Re: Work Plan Addendum - Site Assessment Activity

76 Service Station No. 6129 / WNO 4583 ATC Project No. 75.75118.4583 / 75W02 3420 35th Avenue Oakland, California

Work Plan Addendum – Site Assessment Activity 76 Service Station No. 6129 3420 35th Avenue Oakland, California

Figure 2 - Site Map with Proposed Well Location

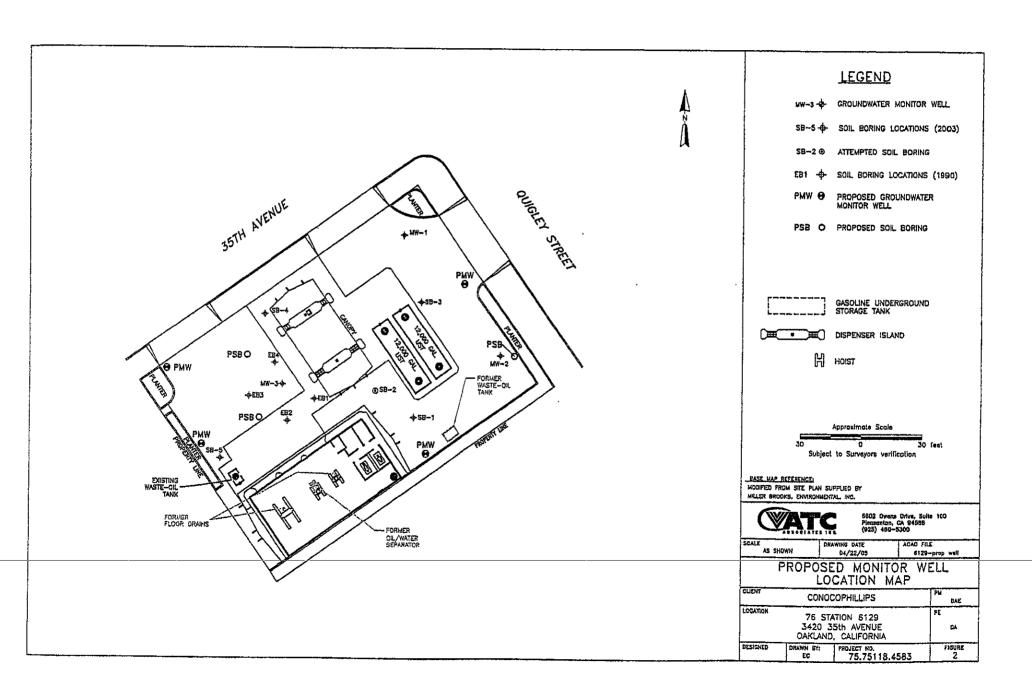
The Miller Brooks' Work Plan describes the completion of six soil borings and the completion of two monitor wells within two of the borings. Thus, two monitor wells and four soil borings would be completed (refer to page 3 of the Work Plan). However, Figure 2 of the Work Plan depicts three monitor well locations and three additional soil borings. The intent of the proposed activity was unclear.

To resolve the discrepancy, ATC reviewed the historic site data and now recommends four monitor wells be installed in addition to three soil borings, (refer to Figure 2 which depicts the new locations). ATC concurs with the pre-drilling, well construction, boring completion, soil/groundwater sampling, analytical analysis, and reporting aspects of the Miller Brooks Work Plan dated October 11, 2004. This document has been attached for you review.
